1 REVISED FLOOR PLAN - BUILDING #800
SCALE 1/16" = 1'-0"

**NORTHEASTERN TECHNICAL COLLEGE
BUILDING #800 RENOVATION**
CHERAW SOUTH CAROLINA

REVISED FLOOR PLAN: BUILDING #800
4420B\ A1.1.aec
COMM. NO.: 4420B
DRAWN BY: FJF
CHECKED BY: AWS
DATE: JAN. 19, 2018
SHEET NO. A1.1

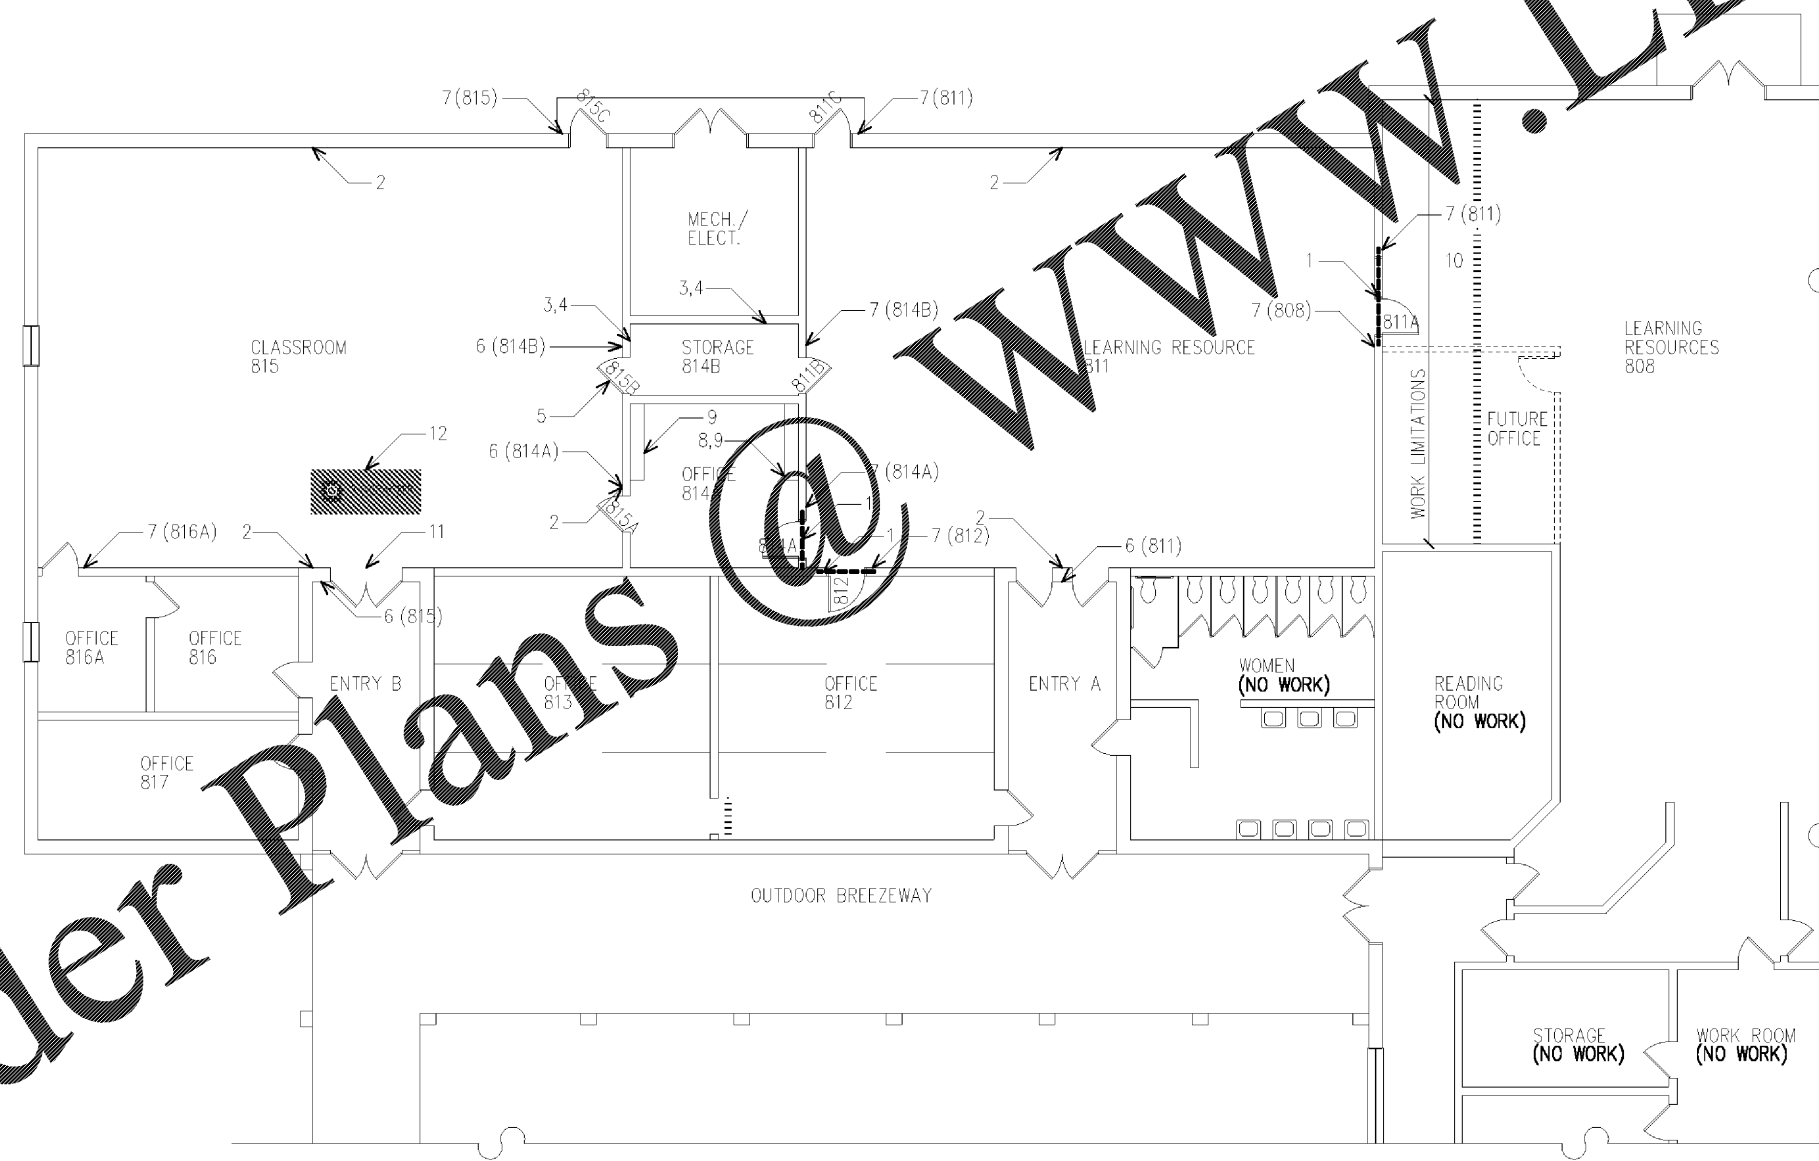
REVISED KEYNOTES

1. PROVIDE NEW PRE-CAST LINTEL AT NEW CMU OPENING. BEARING 8" MINIMUM EACH SIDE ON SOLID GROUTED CMU JAMBS.
2. REPAIR EXISTING CMU WALL WHERE EXISTING PERPENDICULAR WALL IS REMOVED. PRIME AND PAINT WALL CORNER TO CORNER.

3. REPAIR EXISTING CMU WALL WHERE EXISTING PLUMBING SUPPLY IS CAPPED IN WALL.
4. REPAIR EXISTING CONCRETE FLOOR WHERE EXISTING PLUMBING WASTE IS CAPPED BELOW SLAB.

5. PROVIDE NEW 1/4" TEMPERED GLASS PANEL IN EXISTING SOLID CORE WOOD DOOR. SIZE 24"Wx34"H.
6. REINSTALL SALVAGED ROOM IDENTIFICATION NUMBER ON ROOM NUMBER IDENTIFIED WITH KEYNOTE. REFER TO SPECIFICATION SECTION 101423 FOR MOUNTING REQUIREMENTS.

7. PROVIDE NEW ROOM IDENTIFICATION NUMBER AS SPECIFIED.
8. PROVIDE NEW WOOD TRIM WHERE EXISTING BOOK CASE SECTION WAS SELECTIVELY DEMOLISHED FROM SECTION TO REMAIN. PRIME AND PAINT.

9. PRIME AND PAINT EXISTING BOOK CASE AND SHELVING TO REMAIN.
10. TOUCH UP PAINT WHERE EXISTING SURFACE WIRE MOULD AND DATA DEVICES ARE REMOVED BY OWNER. PRIME AND PAINT NEW CONSTRUCTION TO BLEND WITH EXISTING.

11. PROVIDE NEW SIGN ON DOOR TO READ, "THIS DOOR TO REMAIN UNLOCKED WHEN BUILDING IS OCCUPIED". TEXT SHALL BE 1" LETTERS.
12. PROVIDE NORTHEASTERN TECHNICAL COLLEGE LOGO IN ALTERNATE FLOOR. APPROXIMATE LOGO DIMENSION 8 FEET WIDE.
